Natural Resources Defense Council
American Council for an Energy-Efficient Economy
Appliance Standards Awareness Project

RE: Docket Number EERE-2010-BT-TP-0021 / RIN 1904-AC08: Test Procedure for Residential Clothes Washers

Figure 1.

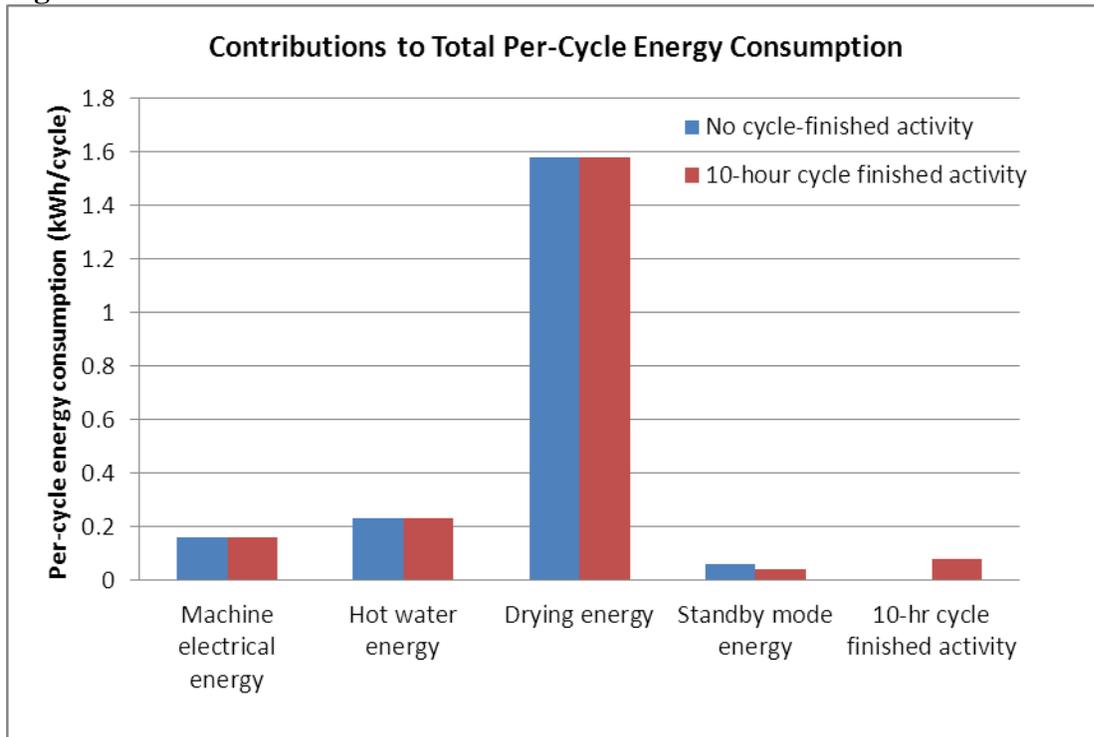
In the SNOPR, DOE tested one model of washer which included periodic tumbling and air circulation in the cycle finished mode. The resulting energy use, as calculated with and without inclusion of the cycle-finished mode energy, is shown in Figure 1 (as reproduced from the SNOPR).

DOE states that the inclusion of cycle-finished mode in this example adds a net 0.08 kWh per cycle – a 3% increase in energy use. While this is not a proportionally large energy increase, it is still a significant one. With drying energy consumption dominating the per-cycle energy consumption, significant changes in non-drying energy consumption are difficult to appreciate. Figure 2 shows more clearly how energy use changes in the non-drying portion of the cycle.

Figure 2.

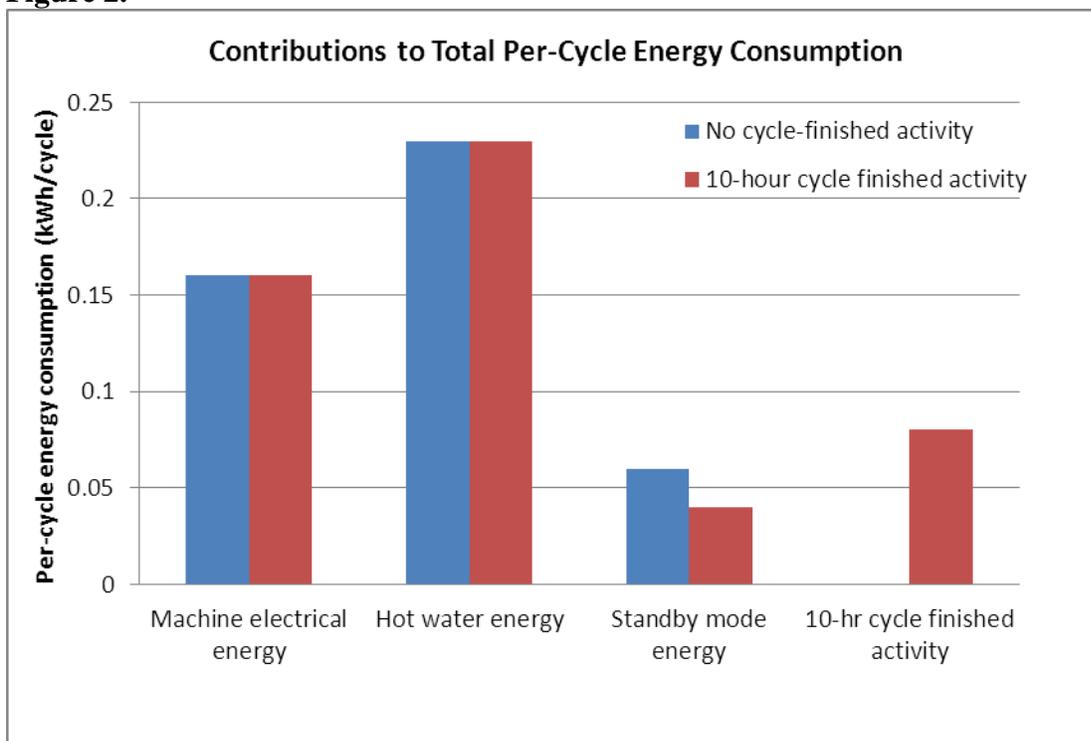
In this example, inclusion of cycle-finished mode energy use doubles the amount of energy in the “low-power” modes, causing the energy consumption in these modes to approach the level of energy used by the machine during the active part of the cycle. While it is true that cycle-finished mode represents a small portion of overall energy use, the energy use is at a level that has qualified other modes for inclusion in the test procedure. Therefore we believe that cycle-finished mode represents energy use too large to be ignored.
